Service Bulletin No. 339

MODEL D Series Coaches equipped w/ C13 engine & 50DN alternator	TYPE Field Change Program	SECTION/GROUP 7 – Electrical	DATE
SUBJECT 50DN ALTERNATOR CABLE CHAFING			
CONDITIONS

Ref. NHTSA Recall No.: 09V-XXX

Figure 1. Pre-2007 C13 engine configuration.

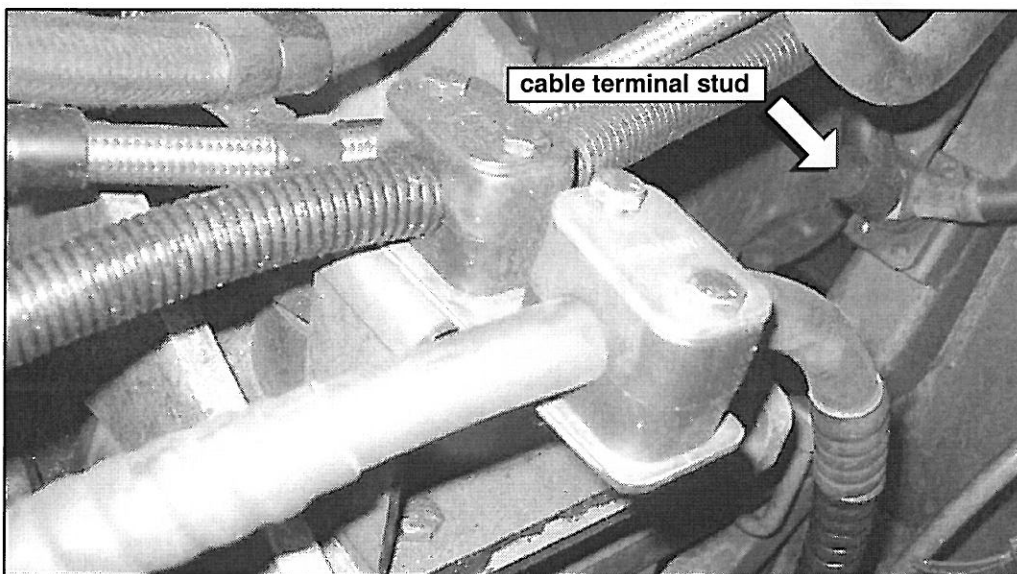
1. Turn the main battery disconnect switch to the OFF position. Chock both sides of the tires.
2. Open the engine compartment and curbside, rear side service compartment doors.
3. Locate the 50DN alternator. Disconnect the alternator cable from the 50DN alternator.
4. Remove and discard the alternator cable support bracket. Retain the mounting bolts.
5. Locate the cable terminal stud on the forward wall of the curbside, rear side service compartment (refer to Figure 1 or Figure 2). Remove and retain the nut. Remove the alternator cable from the cable terminal stud.

Figure 3. Pre-2007 C13 engine configuration.

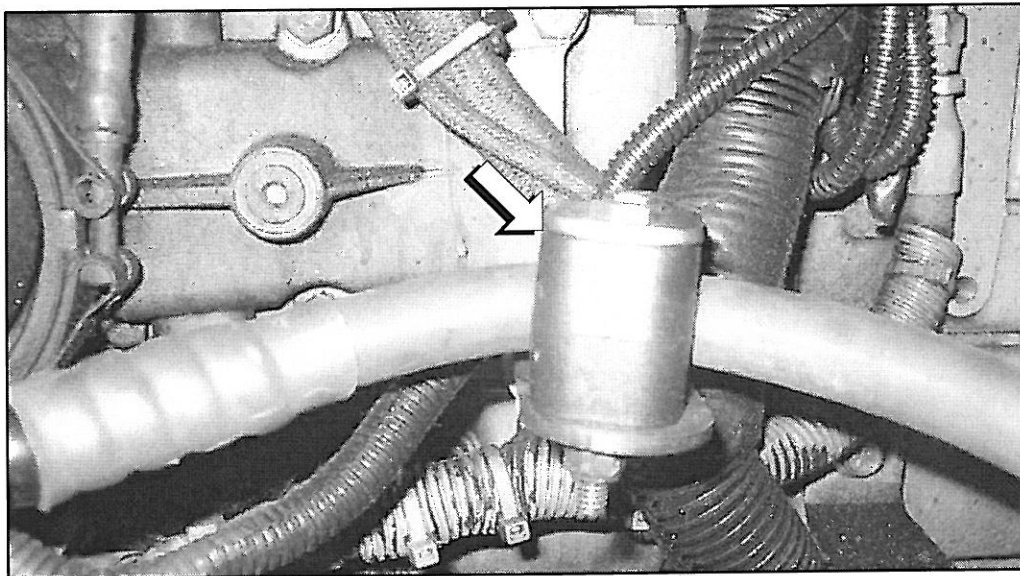
6. Follow the routing of the alternator cable along the curbside of the C13 engine. Release alternator cable from existing split clamps (refer to Figure 3 or Figure 4). Remove and discard the alternator cable.

- Remove the existing split clamps with new split clamp, p/n 19-04-0419 (refer to Figure 3 or Figure 4). Use existing capscrew 19-1-376 and lock nut 19-3-2 to secure alternator cable. Torque to 9 ft. lbs.
- Remove and discard existing P clamp on alternator cable (refer to Figure 6). Use existing hardware, install new P clamp, p/n 19-4-26.

Figure 7. Pre-2007 C13 engine configuration.

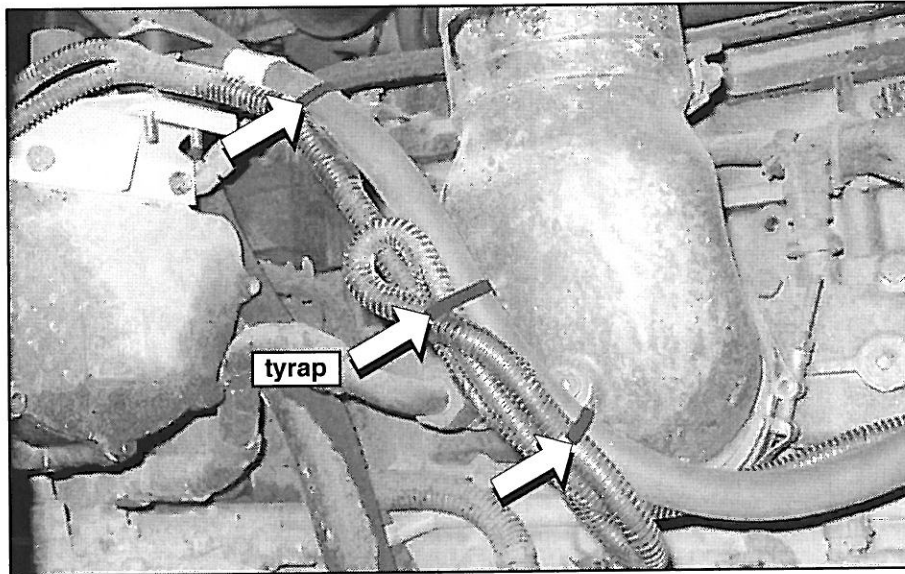
For coaches equipped with the Pre-2007 C13 engine configuration, use tyrap, p/n 19-11-569, to secure existing field wire split loom to the alternator cable (refer to Figure 7).
